**GEORGETOWN MIDDLE-HIGH SCHOOL RENOVATIONS
Georgetown, MA**

ADDENDUM NO.2

February 13, 2015

RS2-01
Ref. Dwg. 6/S2-1-0

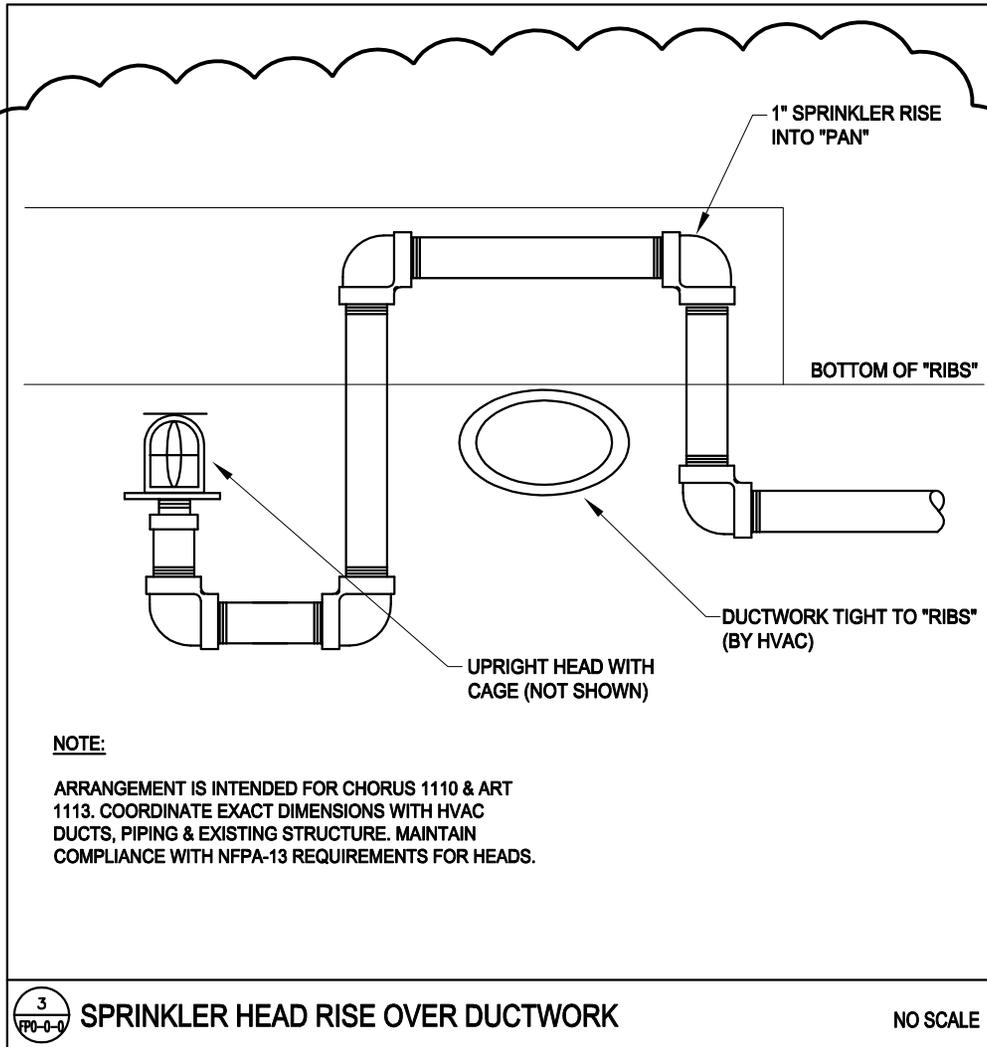
TYPICAL INFILL AT EXISTING SLAB ON GRADE DETAIL

FOR LOCATIONS, QUANTITY AND DIMENSIONS, COORDINATE WITH ARCHITECTURAL, HVAC, ELECTRICAL, PLUMBING AND FIRE PROTECTION DRAWINGS.

RFP2-01
 Ref. Dwg. FP0-0-0

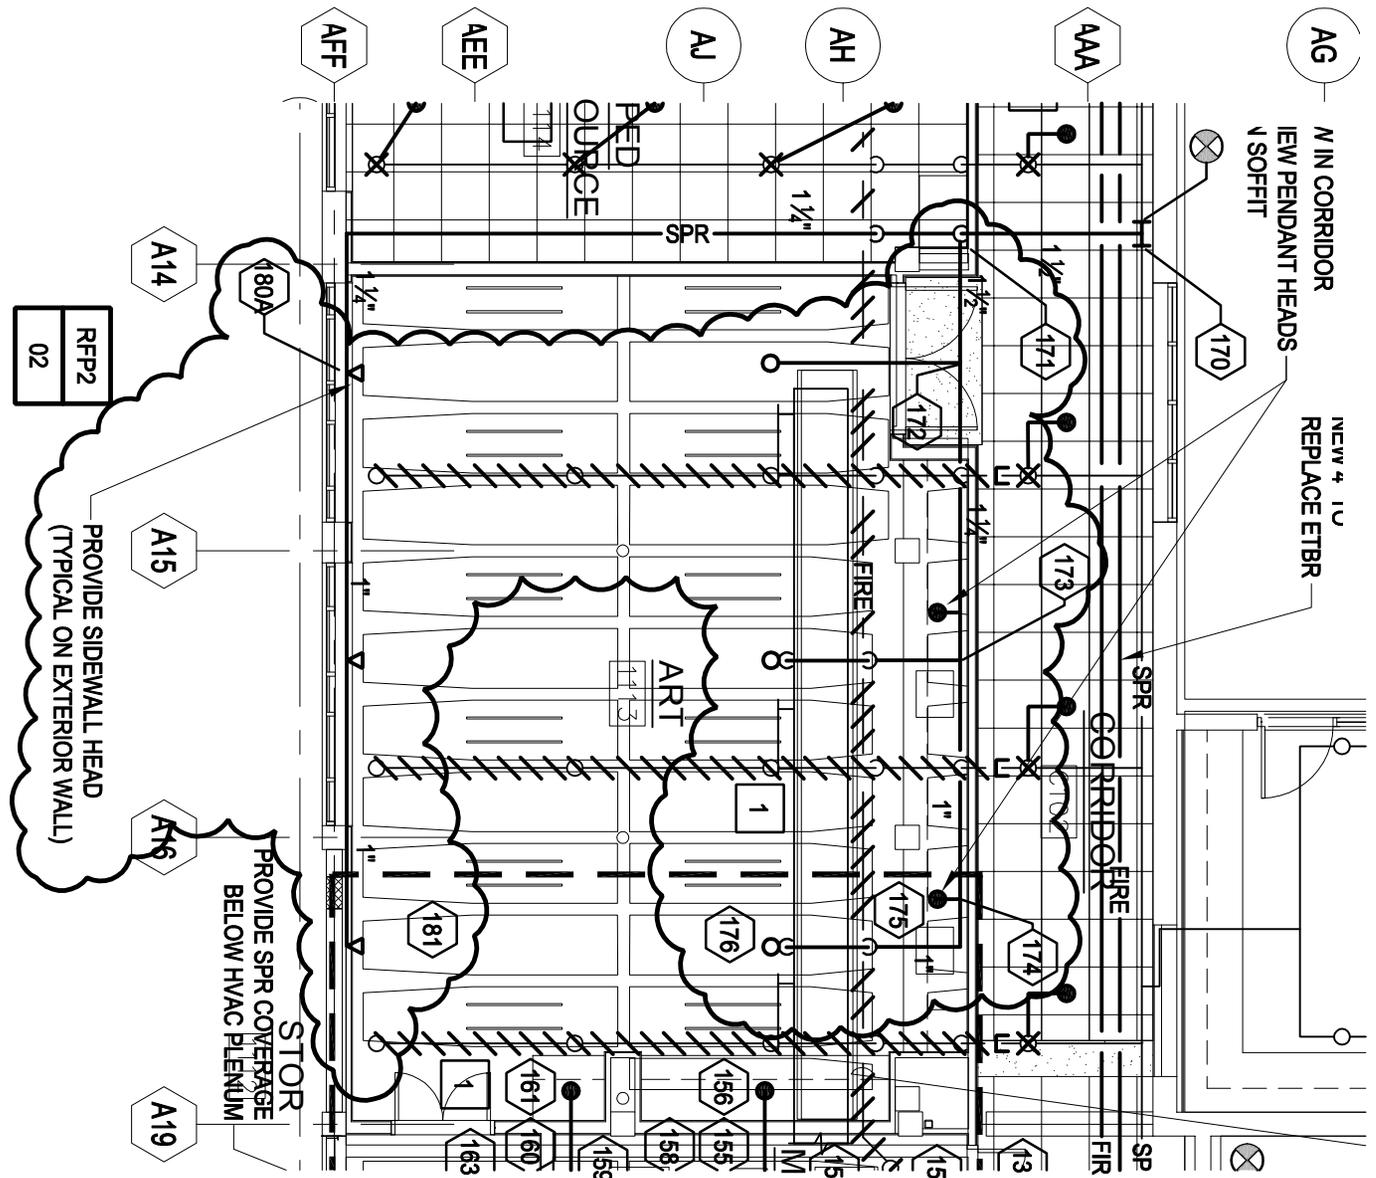
Refer to attached sketch RFP2-01. Revise Fire Protection Detail #3 as shown.

RFP2-02
 Ref. Dwg. FP1-1-1A

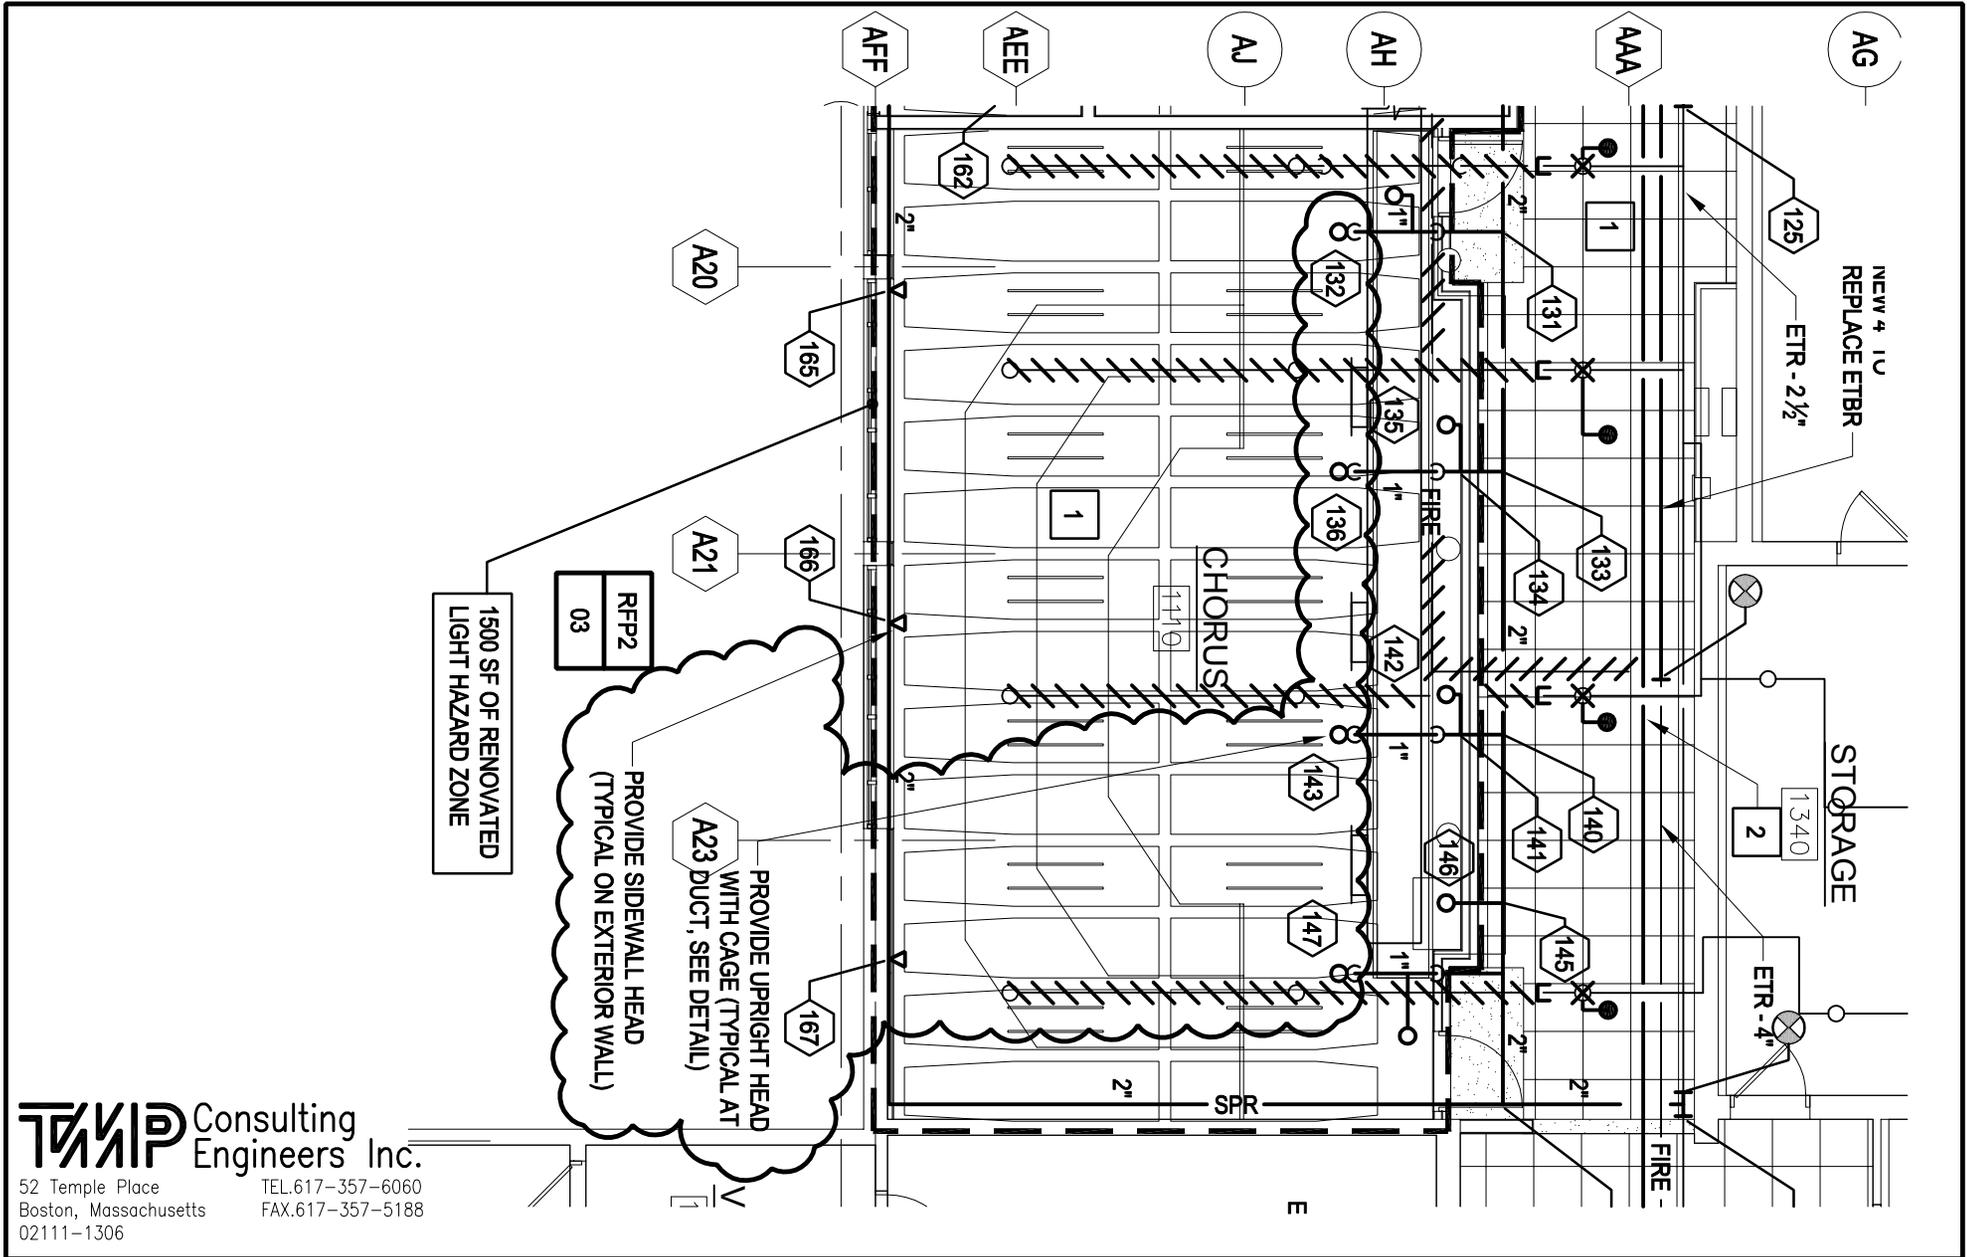
Refer to attached sketch RFP2-02. Revise Sprinkler layout in Art 1113 as shown.

D·R·A
 RFP2-03
 Ref. Dwg. FP1-1-A

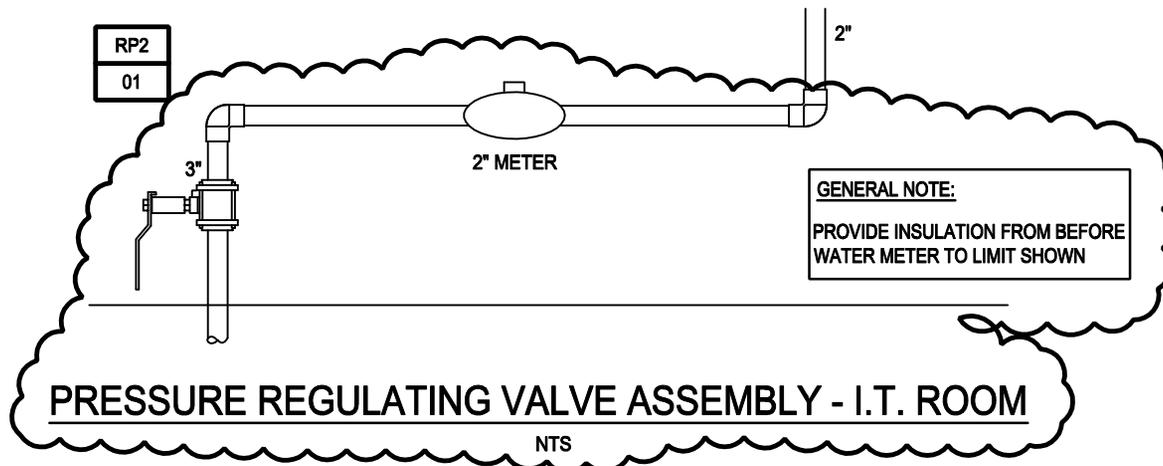
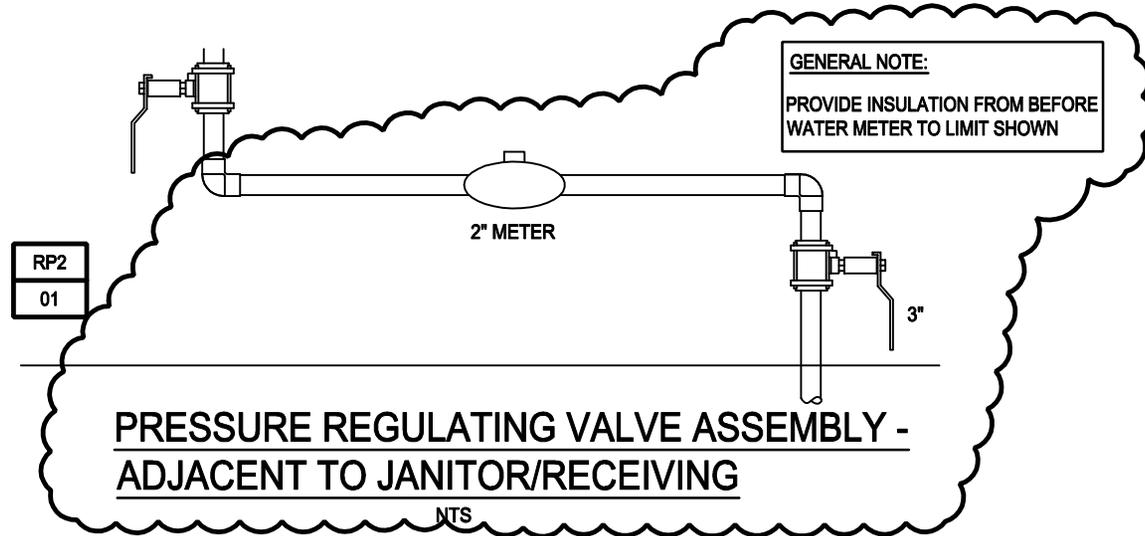
Refer to attached sketch RFP2-03. Revise Sprinkler layout in Chorus 1110 as shown.

RP2-01
 Ref. Dwg. P0-0-0

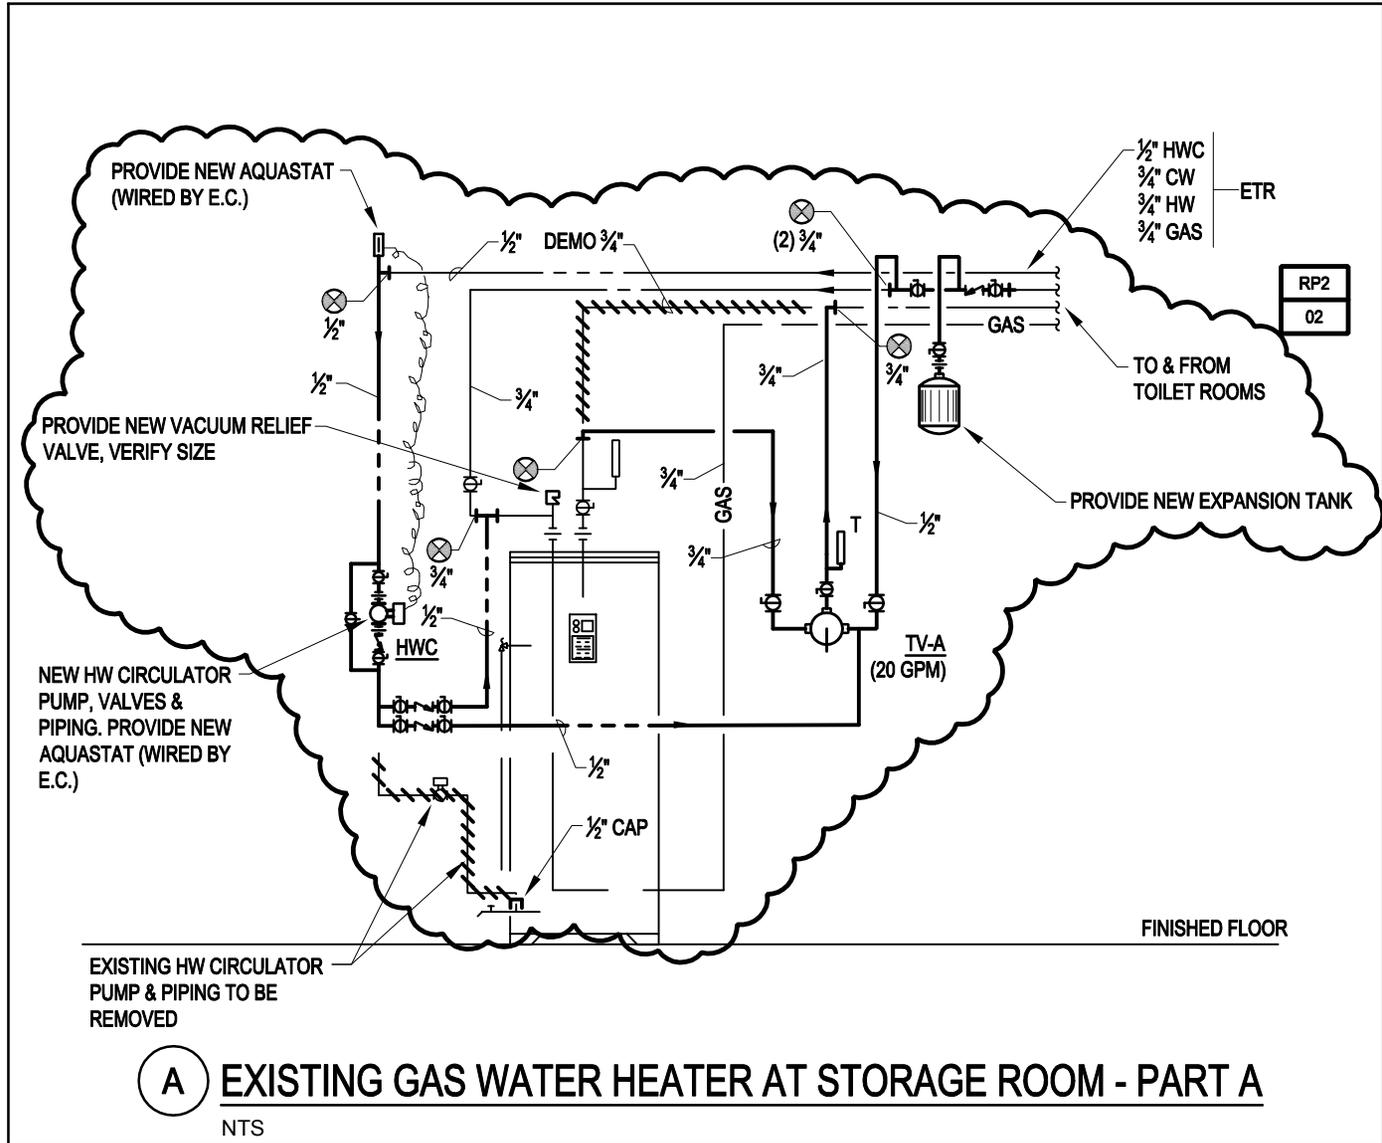
REVISE Pressure Regulating Details as shown. Refer to attached sketch RP2-01.

RP2-02
 Ref. Dwg. P0-0-0

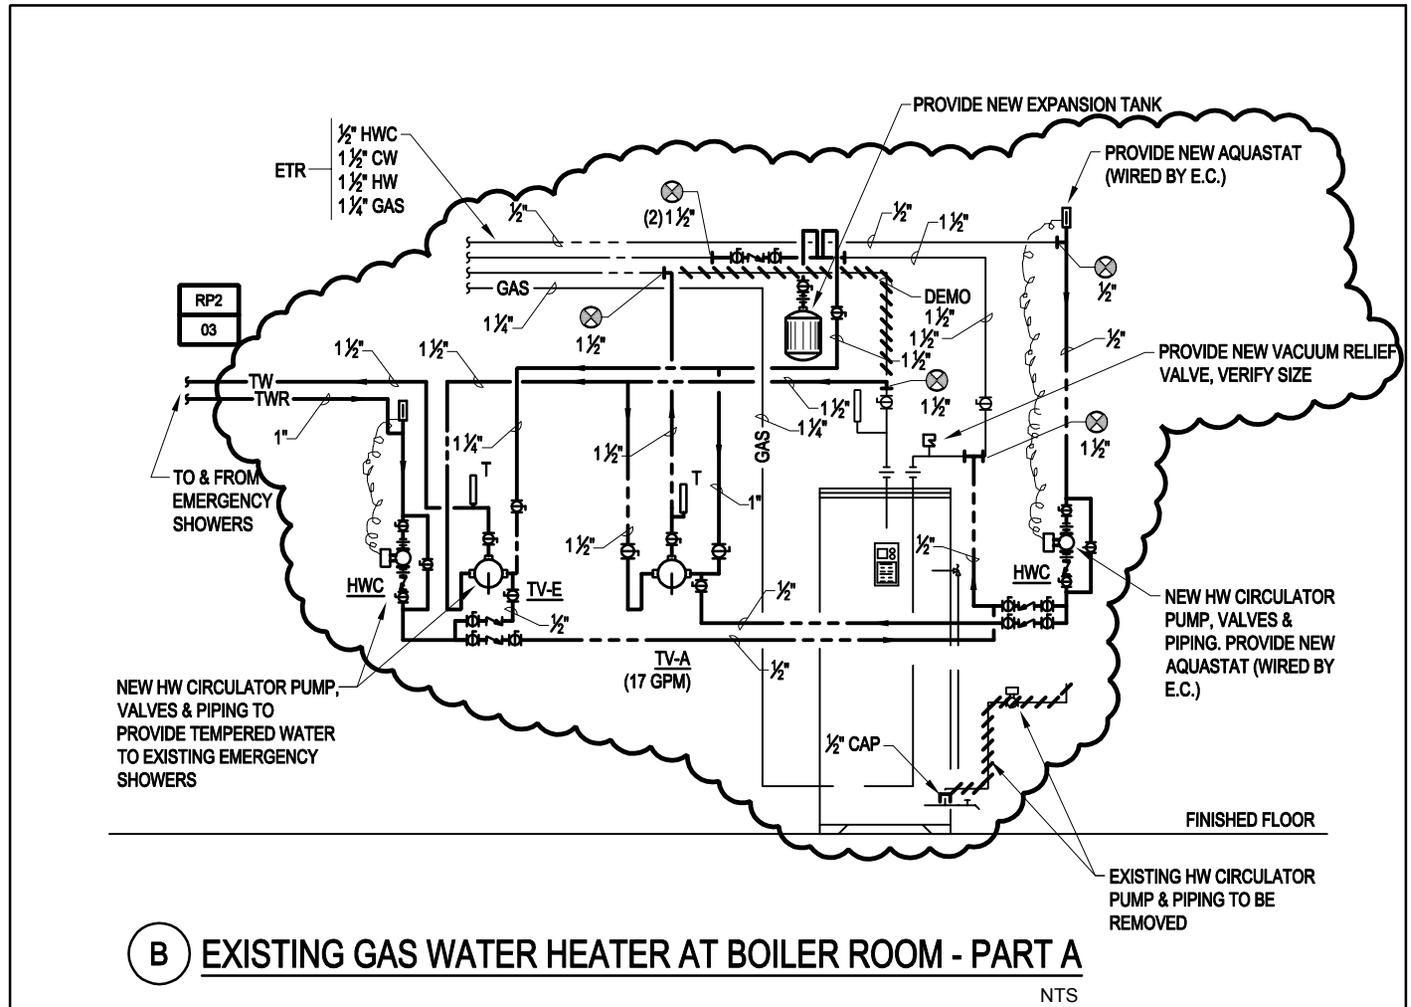
- ADD 2-33 P0-0-0 PLUMBING LEGEND & DETAILS**
REVISE Water Heater Detail A as shown. Refer to sketch RP2-02.
- ADD 2-34 P0-0-0 PLUMBING LEGEND & DETAILS**
REVISE Water Heater Detail B as shown. Refer to attached sketch RP2-03.

RP2-06
Ref. Dwg. P1-1-1A

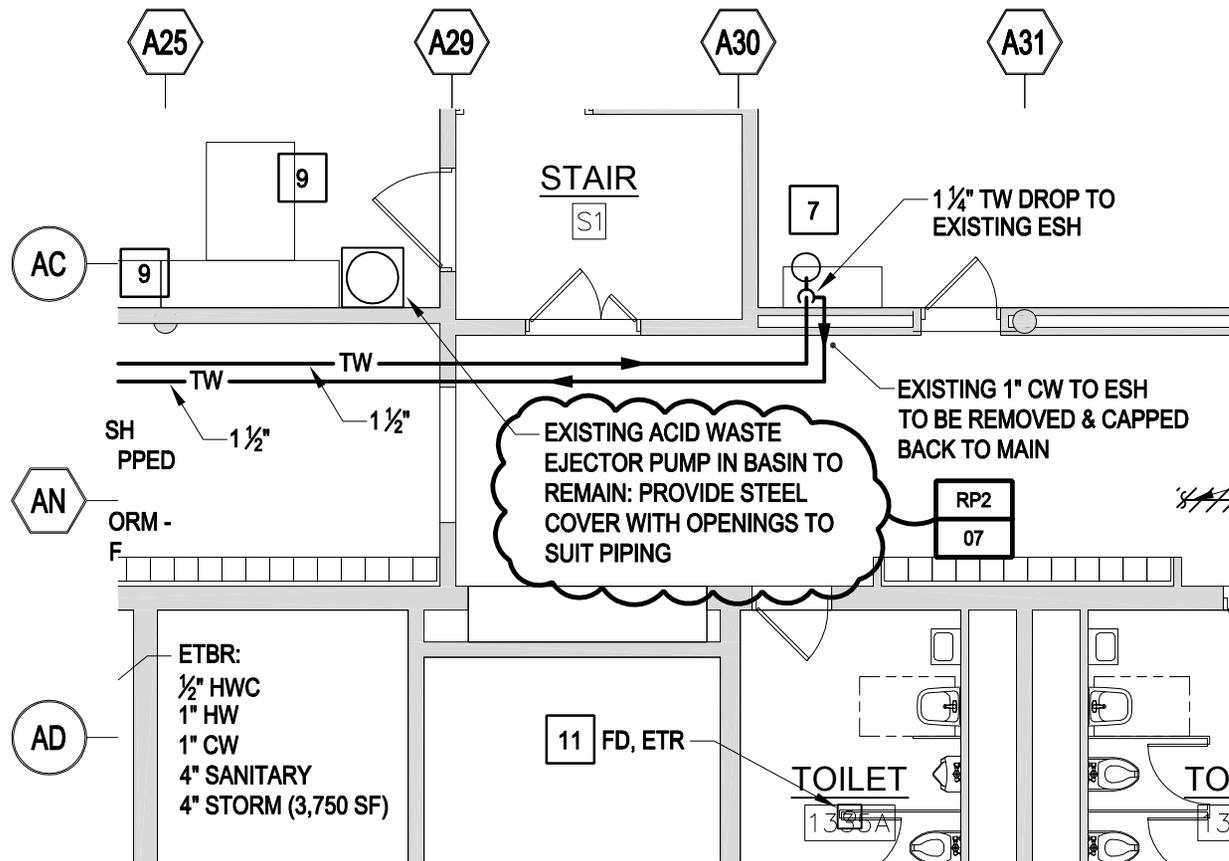
- ADD 2-37 P1-1-1A PLUMBING FIRST FLOOR PLAN AREA A**
REVISE note at existing Acid Waste Ejector. Refer to attached sketch RP2-06.
- ADD 2-38 P1-1-1A PLUMBING FIRST FLOOR PLAN AREA A**
REVISE note at existing Acid Waste Ejector. Refer to attached sketch RP2-07.
